## **BURTON-PATE INDUSTRIAL PARK SUBDIVISION,** **RESUBDIVISION OF LOTS 1 AND 2**

APPLICATION NUMBER 4 DATE February 7, 2013  
 APPLICANT Burton-Pate Industrial Park Subdivision, Resubdivision of Lots 1 and 2  
 REQUEST Subdivision

# DETAIL SITE PLAN

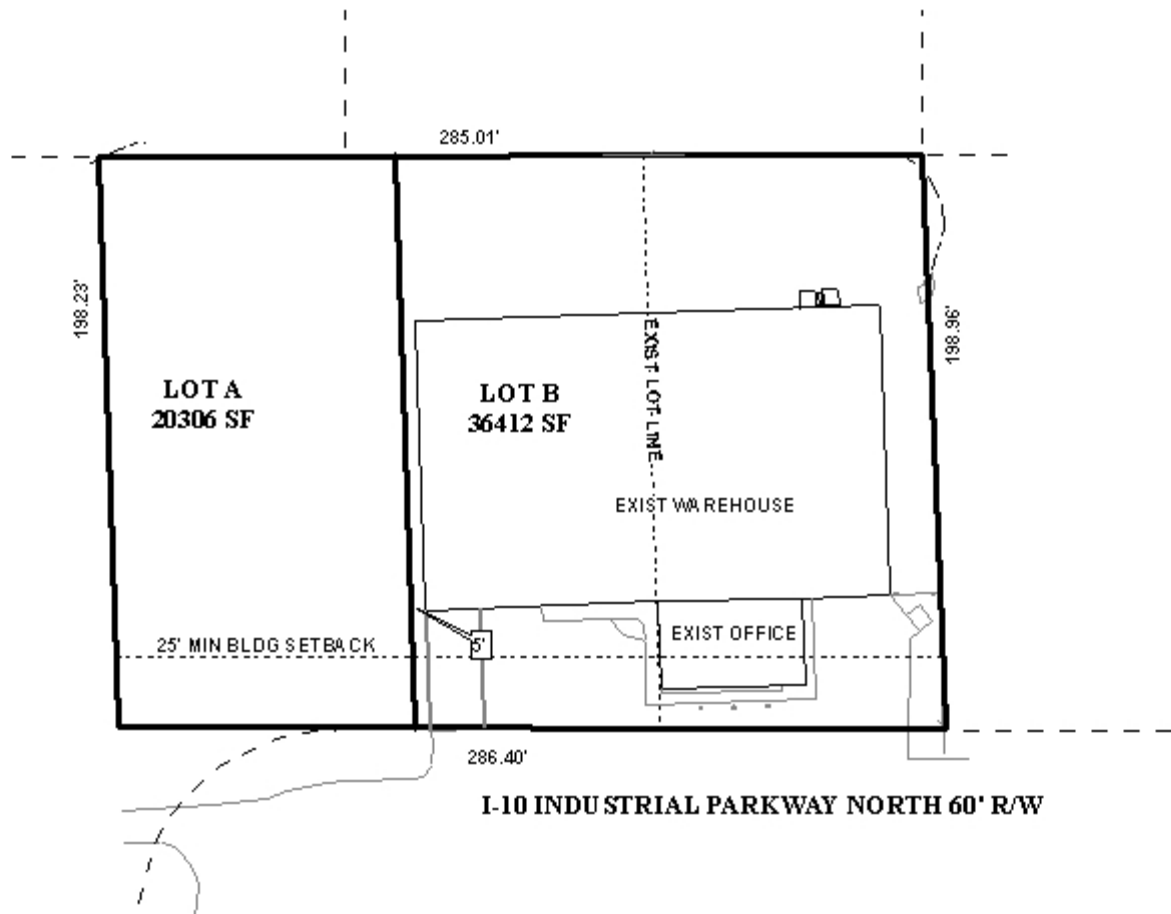
The lot sizes are labeled, and the proposed lots would exceed the minimum size requirements of Section V.D.2. of the Subdivision Regulations. The lot sizes should be retained in square feet and acres on the Final Plat, as on the preliminary plat, if approved.

The site fronts onto I-10 Industrial Parkway North, a minor street with no curb and gutter. The preliminary plat illustrates a compliant 60' right-of-way making no dedications necessary.

The 25-foot minimum building setback line, required in Section V.D.9., is illustrated and labeled along all frontages on the preliminary plat. If approved, the 25-foot building setback line should be retained on the Final Plat. There is a portion of an existing office located in the required front setback, however because the encroachment is existing, and no new construction is proposed at that time, it is considered a legal non-conforming structure. It should be noted however that any future construction must comply with setback requirements.

As a means of access management, a note should be placed on the Final Plat, if approved, stating that Lot A is limited to one curb cut to I-10 Industrial Parkway North, and Lot B is limited to existing curb cuts to I-10 Industrial Parkway North, with the size, location and design to be approved by Traffic Engineering and conform to AASHTO standards. It should also be noted that the preliminary plat incorrectly labels the street as "I-10 Industriall Parkway North". If approved, the street name should be revised to be spelled correctly.

- 1) illustration of the 25' minimum building setback line;
- 2) labeling of the lot size in square feet and acres;
- 3) revision of the street name to correctly read "I-10 Industrial Parkway North";

- 4) placement of a note that future development of the site will require full compliance with all municipal codes and ordinances;
- 5) compliance with Engineering comments (*The following comments should be addressed prior to review, acceptance and signature by the City Engineer: 1. Provide all of the required information on the Final Plat (i.e. signature blocks, signatures, certification statements, legal description, required notes). 2. A signature for the Traffic Engineering Department shall be placed on the Final Plat. 3. Add a note to the Plat stating that storm water detention will be required for any unapproved development (since 1984) and any future addition(s) and/or land disturbing activity in accordance with the Storm Water Management and Flood Control Ordinance (Mobile City Code, Chapter 17 , Ordinance*

#65-007 & #65-045). 4. Provide a drainage easement to contain any existing drainage ditch/swale. Size and location to be approved by the City Engineer. 5. Show approximate centerline of existing drainage ditch located near the NE corner. 6. The existing dumpster shall contain its own storm runoff, collect it in a central drain, and transport it to the Sanitary Sewer system. 7. Add a note to the plat that any proposed dumpster(s) shall contain its own storm runoff, collect it in a central drain, and transport it to the Sanitary Sewer system.);

- 6) compliance with Fire Department comments (All projects within the City of Mobile Fire Jurisdiction must comply with the requirements of the 2009 International Fire Code, as adopted by the City of Mobile.);
- 7) placement of a note on the Final Plat stating Lot A is limited to one curb cut to I-10 Industrial Parkway North, and Lot B is limited to existing curb cuts to I-10 Industrial Parkway North, with the size, location and design to be approved by Traffic Engineering and conform to AASHTO standards; and
- 8) placement of a note on the Final Plat stating that approval of all applicable Federal, state and local agencies is required for endangered, threatened or otherwise protected species, if any, prior to the issuance of any permits or land disturbance activities.
